SERVICE NOTE

Subject:

- Wear on hoses of water cooling system in the rear fairing.

- All versions of the arv Tanarg trike and especially version ES.

Hoses to be inspected

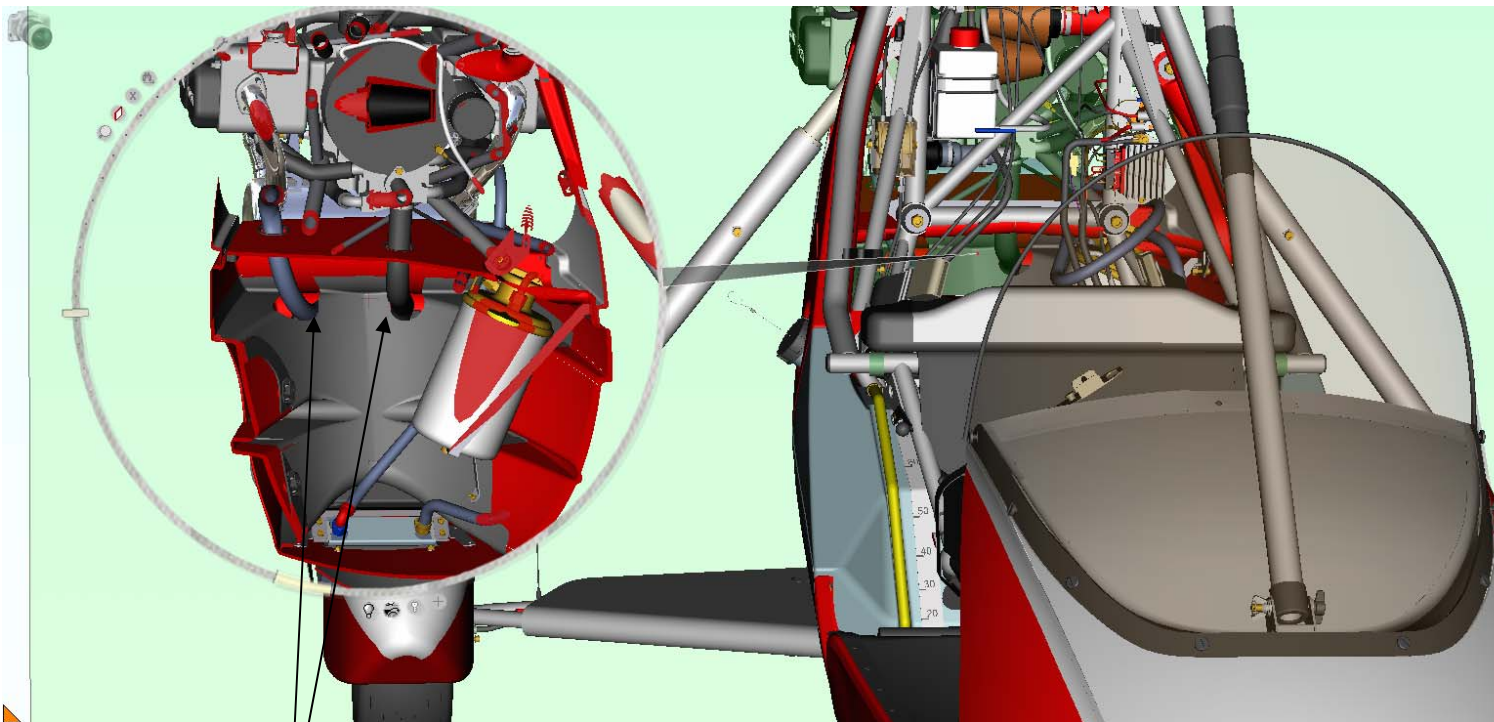
Inspect the water hoses thoroughly and protect areas of contact to avoid wear. Inspect particularly the area near the inside of the rear fairing (output of water radiator).
